**SUBDIVISION,
PLANNED UNIT DEVELOPMENT,
PLANNING APPROVAL &
SIDEWALK WAIVER STAFF REPORT**

Date: November 21, 2013

<u>NAME</u>	Redeemed Community Church Subdivision
<u>SUBDIVISION NAME</u>	Redeemed Community Church Subdivision
<u>LOCATION</u>	6254 Howells Ferry Road (North side of Howells Ferry Road, 500'± West of Grider Road)
<u>CITY COUNCIL DISTRICT</u>	District 7
<u>CURRENT ZONING</u>	R-1, Single-Family Residential
<u>AREA OF PROPERTY</u>	1 Lot / 6.3± Acres
<u>CONTEMPLATED USE</u>	Subdivision Approval to create a legal lot of record from an existing metes-and bounds parcel, Planned Unit Development approval to allow multiple buildings on a single building site, Planning Approval to allow a church in an R-1, Single-Family Residential District, and Sidewalk Waiver to waive construction of a sidewalk along Howells Ferry Road.
<u>TIME SCHEDULE FOR DEVELOPMENT</u>	Immediate.
<u>ENGINEERING COMMENTS</u>	Subdivision: The following comments should be addressed prior to acceptance and signature by the City Engineer: a. Provide all of the required information on the Plat (i.e. signature blocks, signatures, certification statements, written legal description, required notes, legend, sca

SITE PLAN

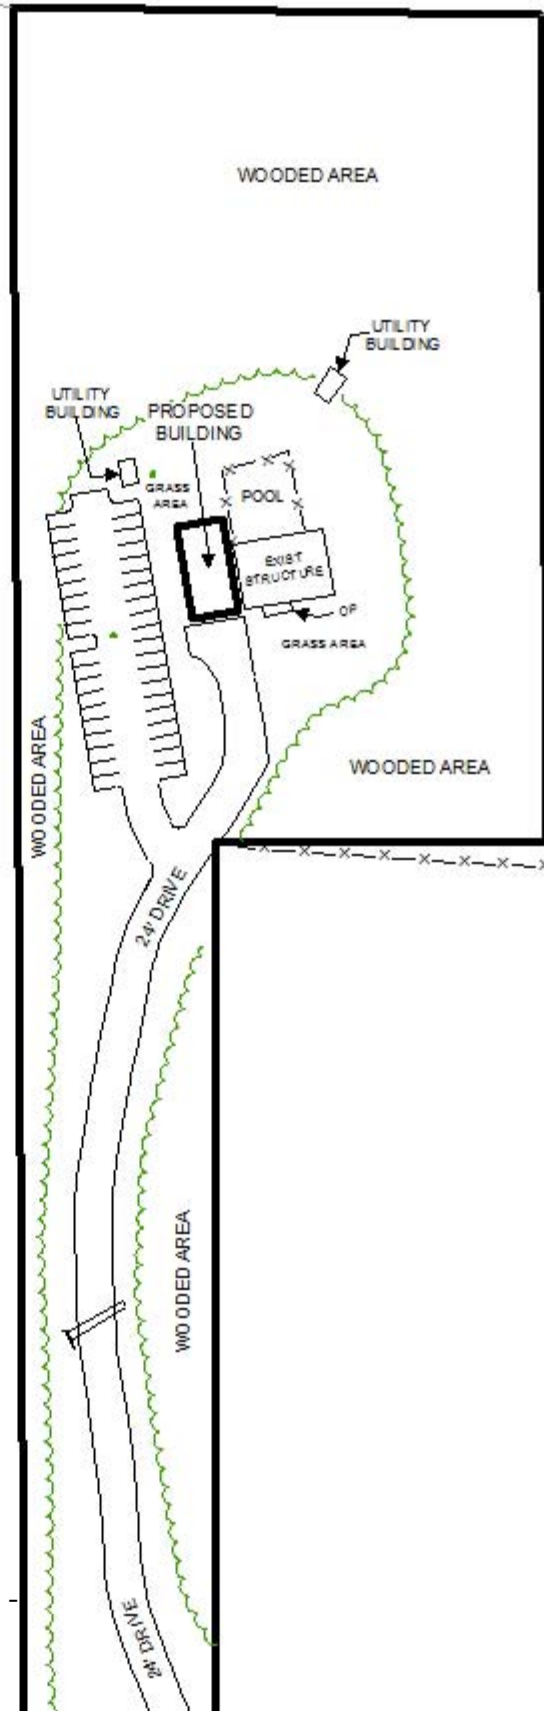
The site plans submitted illustrate the existing and proposed structures, parking area, and 24'-wide entrance drive. A portion of the entrance drive encroaches onto the Northwest corner of the adjacent property to the East; therefore the site plans should be revised to relocate the drive in that area so as to eliminate this encroachment. A note with the applications indicates that the church seating capacity would be 150 people which would require 38 parking spaces. The site plan should be revised to include these calculations. The site plans indicate 39

compliant-sized parking spaces with compliant access and maneuvering area but do not indicate bumper stops or curbing around the parking area. Therefore, the site plans should be revised to indicate such. No handicap accessible parking spaces are depicted. If accessible spaces are required, they must be shown on the site plan, including the required access aisle. It should be noted that a Paving Surface Variance request has been submitted to allow aggregate paving surfaces on the site instead of the required asphalt, concrete or approved alternative paving surfaces, to be heard at the December 2nd Board of Zoning Adjustment meeting.

The site plans should also be revised to illustrate the proposed 30' minimum building setback line along Howells Ferry Road.

No dumpster is indicated on the site plans, nor is there a note on the site plans indicating that no dumpster will be utilized. Therefore, the site plans should be revised to either indicate a compliant dumpster with screening and sanitary sewer drainage connection or a note should be placed on the site plans indicating that there will be no dumpster utilized and also indicating what type of garbage collection will be utilized.

- 1) revision of the site plan to eliminate the driveway encroachment onto the Northwest corner of the adjacent residential property to the East;
- 2) revision of the site plan to include the parking requirement calculations;

- 3) revision of the site plan to indicate either bumper stops within or curbing around the parking area;
- 4) revision of the site plan to show any required handicap accessible parking;

- 10) revision of the site plan to illustrate the 30' minimum building setback line along Howells Ferry Road;
- 11) revision of the site plan to illustrate a compliant City-standard sidewalk along Howells Ferry Road, should the Sidewalk Waiver be denied;

- 12) revision of the site plan to either indicate a compliant dumpster with screening and sanitary sewer drainage connection or the placement of a note on the site plan indicating that there will be no dumpster utilized and also indicating what type of garbage collection will be utilized;
